| APPLICATION NO. | FILING DATE | FIRST NAMED INVENTOR | ATTORNEY DOCKET NO. | CONFIRMATION NO. |
|-----------------|-------------|------------------------|---------------------|------------------|
| 09/966,222 | 09/28/2001 | William James Palmteer | 17658 | 5902 |

CRUZ, LOURDES C

REMARKS

FIG. 1B
CONVENTIONAL
ART

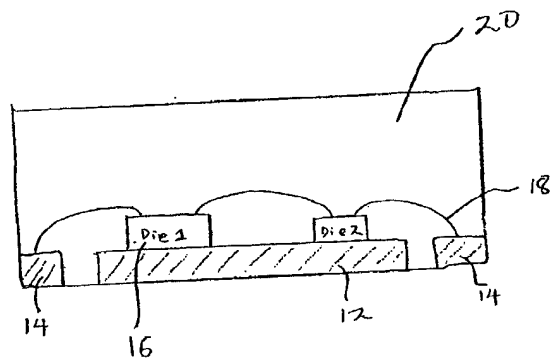
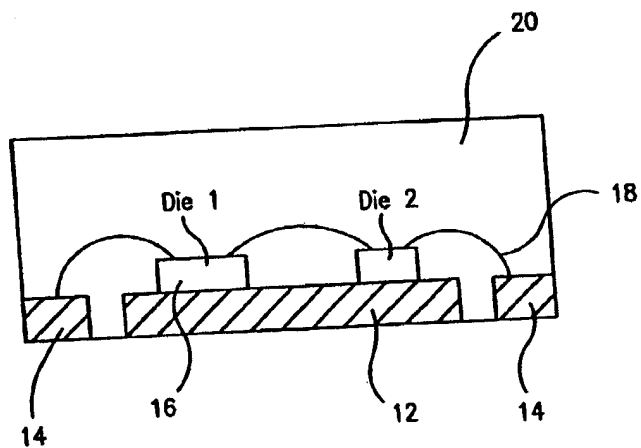
The timely submission under 37 CFR 1.129(a) filed on 12-30-02 is not fully responsive to the prior Office Action because the cross-hatching patterns in the drawings were not amended to comply with the page no. and section of the MPEP mentioned/indicated by the examiner in the previous Office Action. All of the cross hatching patterns should be selected from those shown on page 600-81 of the MPEP based on the material of the part. Also see 35 CFR 184 (h)(3) and MPEP 608.02.

Figures 2A, 2B, 2C, 2D, and 3 have been edited to correct the cross hatching pattern shown in the metal areas of the chip scale package. Figure 1B showing the prior art is correctly cross-hatched in accordance with MPEP §608.02.
